| <b>Well Name:</b> POKER LAKE UNIT 28-21 BS | <b>Well Location:</b> T25S / R31E / SEC 28 / NENW /          | <b>County or Parish/State:</b>             |
| <b>Well Number:</b> 124H                   | <b>Type of Well:</b> CONVENTIONAL GAS WELL                   | <b>Allottee or Tribe Name:</b>             |

Notice of Intent

**Procedure Description:** \*\*Spacing, Casing/Cement, Drilling Variance Changes XTO Permian Operating, LLC requests permission to make the following changes to the original APD: No Additional Surface Disturbance Change BHL fr/50'FNL & 2010'FWL to 2611'FSL & 833'FWL, Section 17-T25S-R31E Casing/Cement design per the attached drilling program. Attachments: C102 Drilling Program Directional Plan Multibowl Diagram

| And 9-5/8", 7-5/8" & 5-1/2" Pin Bottom Mandrel Casing Hangers |  |  | DRAWING NO.                | HBE0000479 |         |

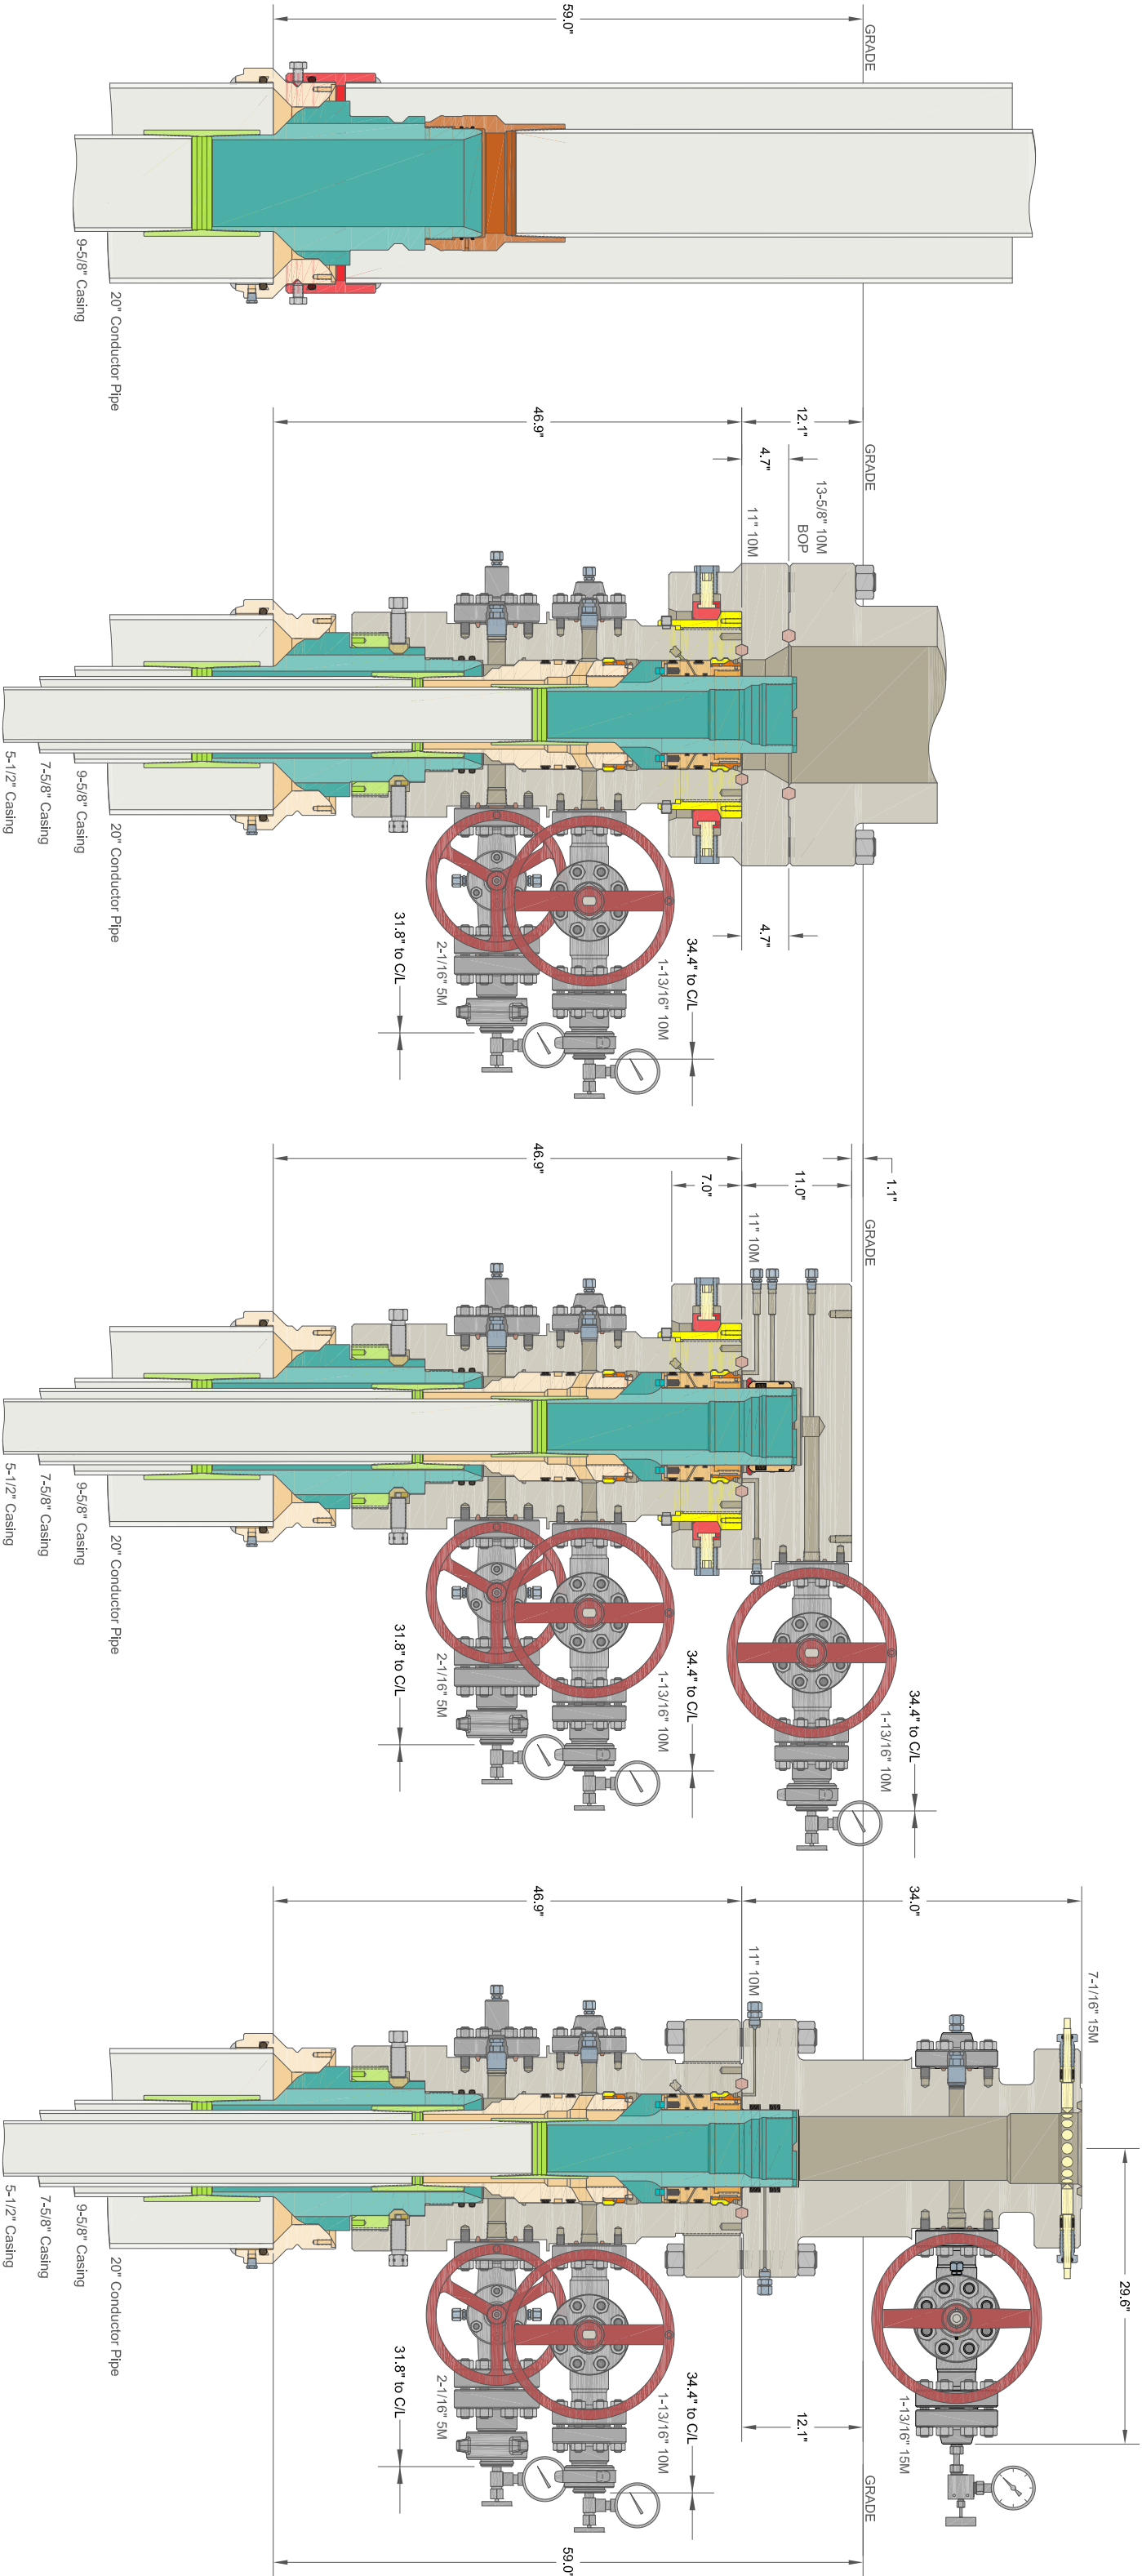
*Permanent Wellhead – Multibowl System*

A. Starting Head: 11" 10M top flange x 9-5/8" SOW bottom

B. Tubing Head: 11" 10M bottom flange x 7-1/16" 15M top flange

- Wellhead will be installed by manufacturer's representatives.

- Manufacturer will monitor welding process to ensure appropriate temperature of seal.
- Operator will test the 7-5/8" casing per BLM Onshore Order 2
- Wellhead Manufacturer representative will not be present for BOP test plug installation

- a. Wellhead shall be installed by manufacturer's representatives, submit documentation with subsequent sundry.
  - b. If the welding is performed by a third party, the manufacturer's representative shall monitor the temperature to verify that it does not exceed the maximum temperature of the seal.
